RE: **Lot 4 Block 6 Unit 18, S.A.D. 228**  
**Volcano Cliffs Subdivision**  
**6616 Kimmick Dr. NW**  
**Grading and Drainage Plan**  
**Engineers Stamp Date; 7-27-17 (D10D00M4)**  
**Pad Certification Date; None**

Based upon the information provided in your submittal received 8/14/17, this plan is cannot be approved for pad certification until the following comments are addressed.

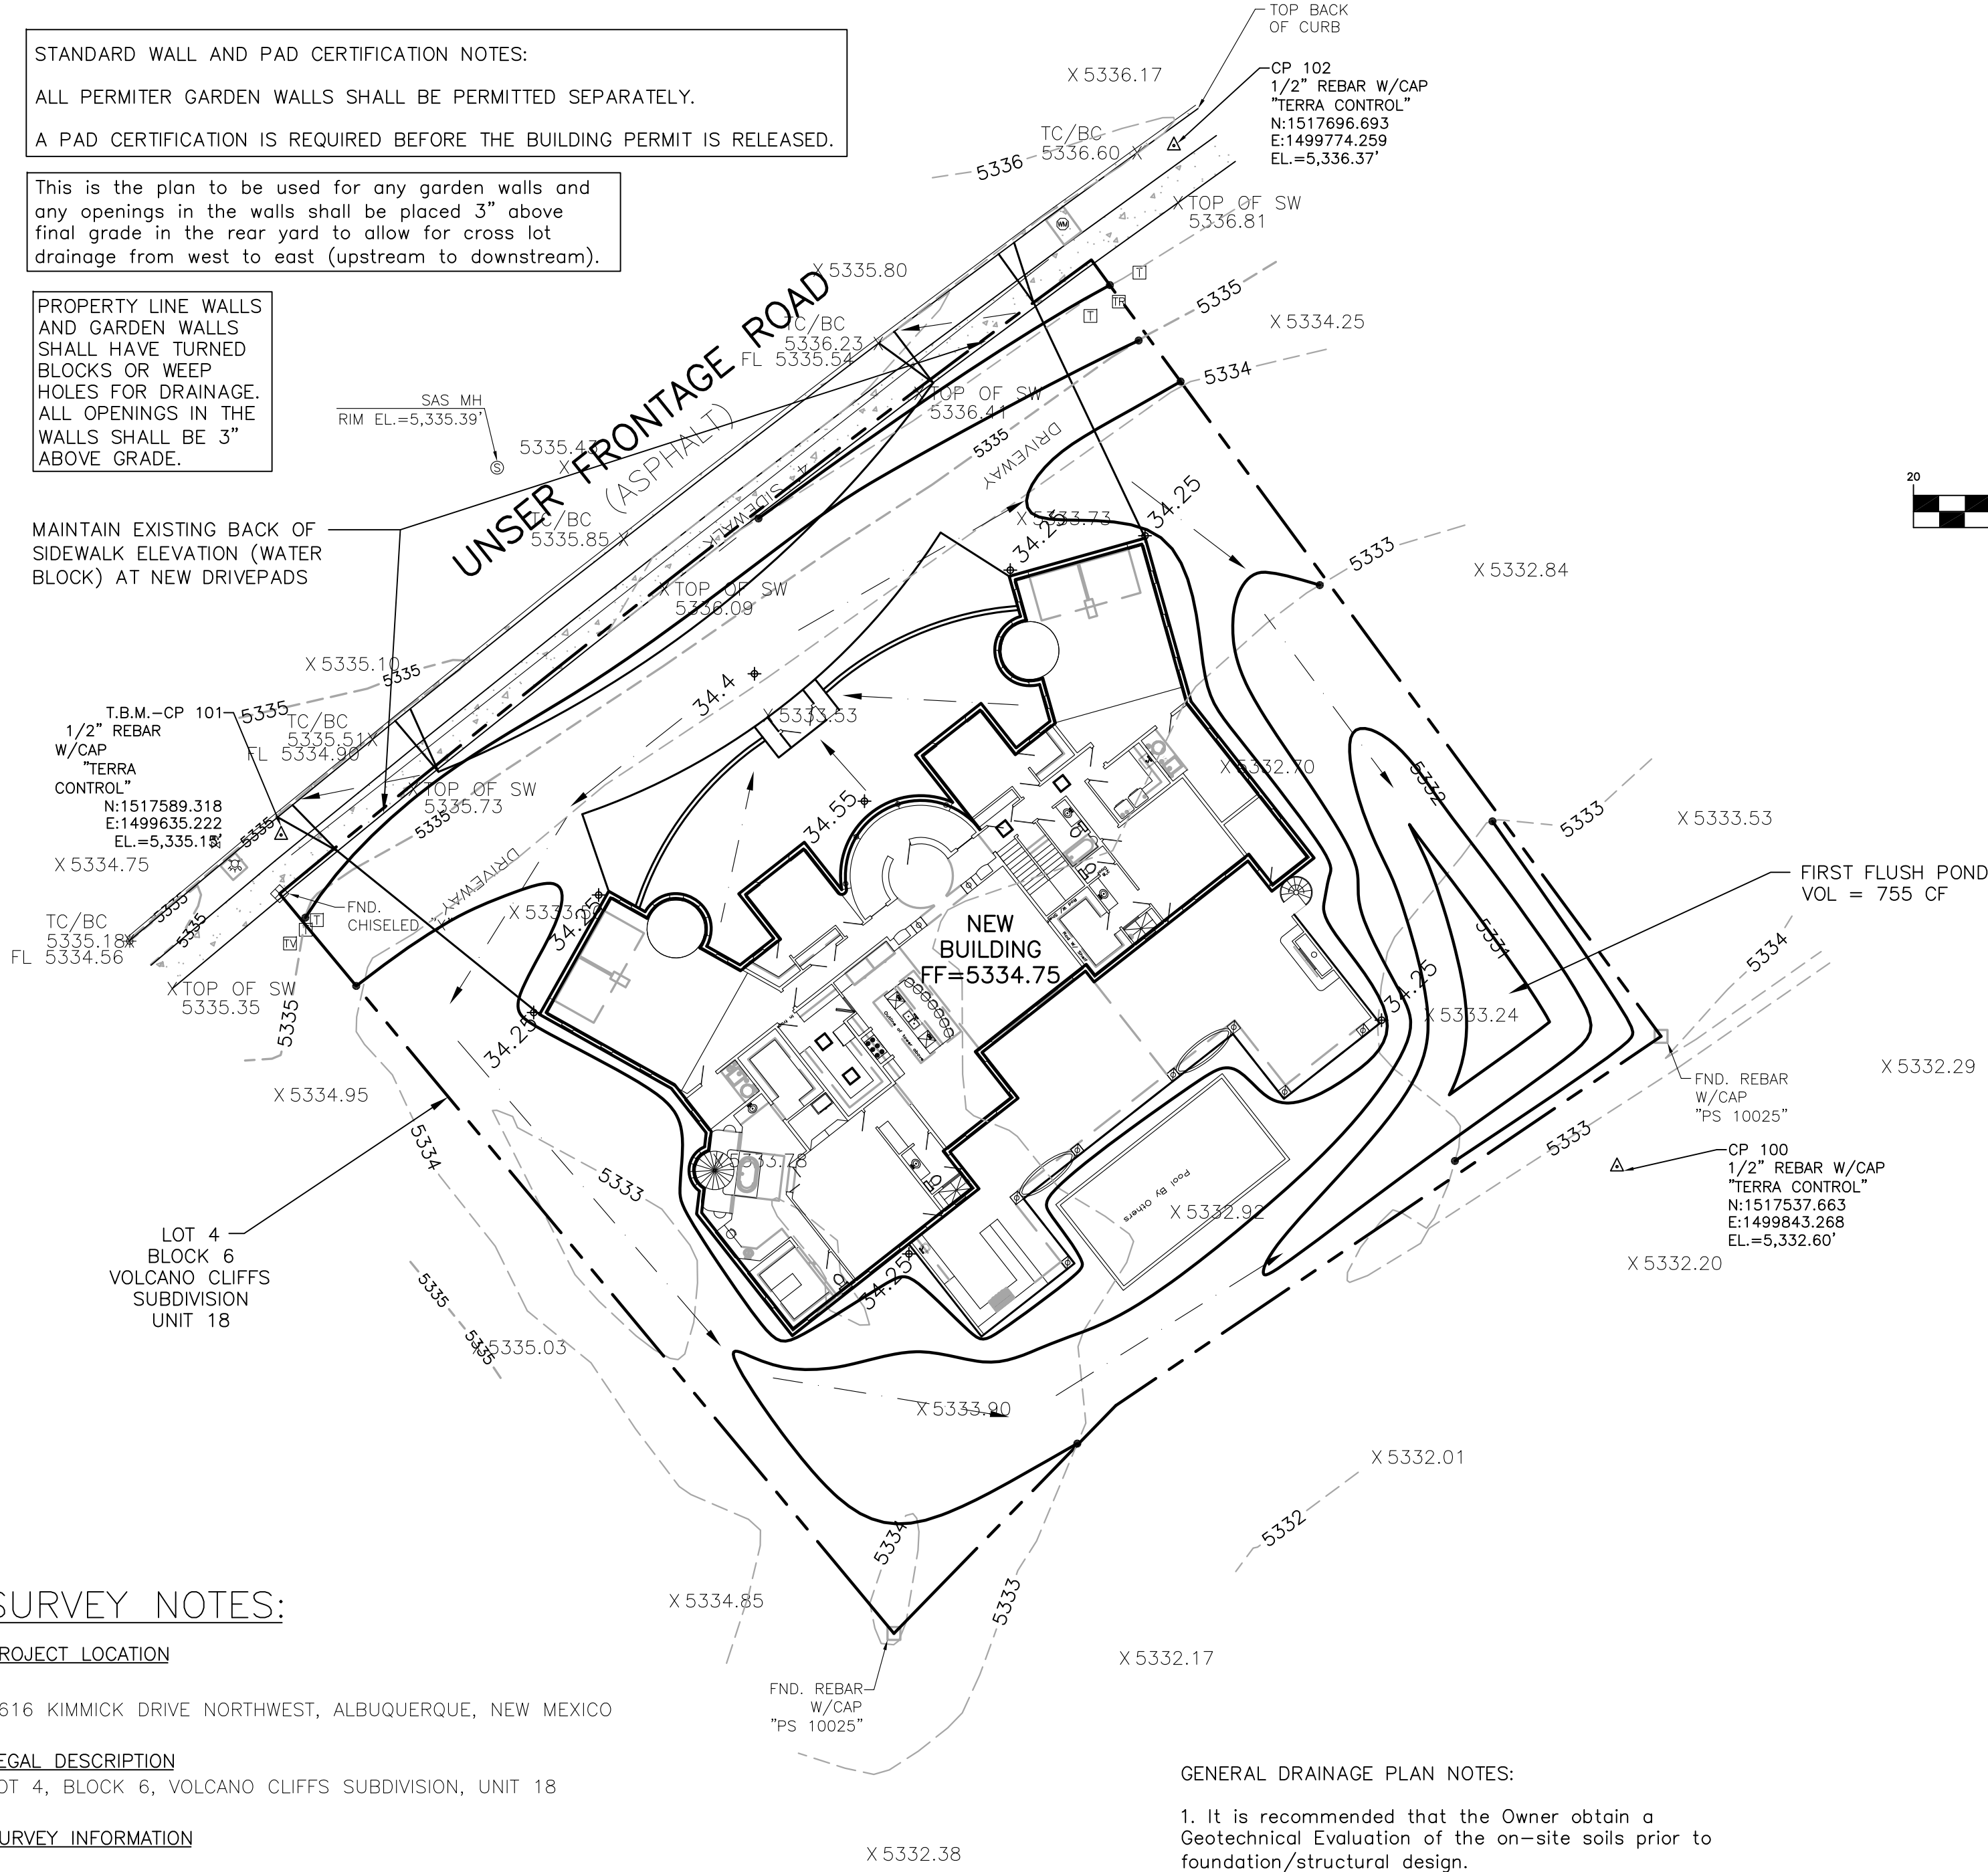
- Provide the Pad Certification language, signed and dated.
- The area is not ready for inspection, compaction roller at this location.
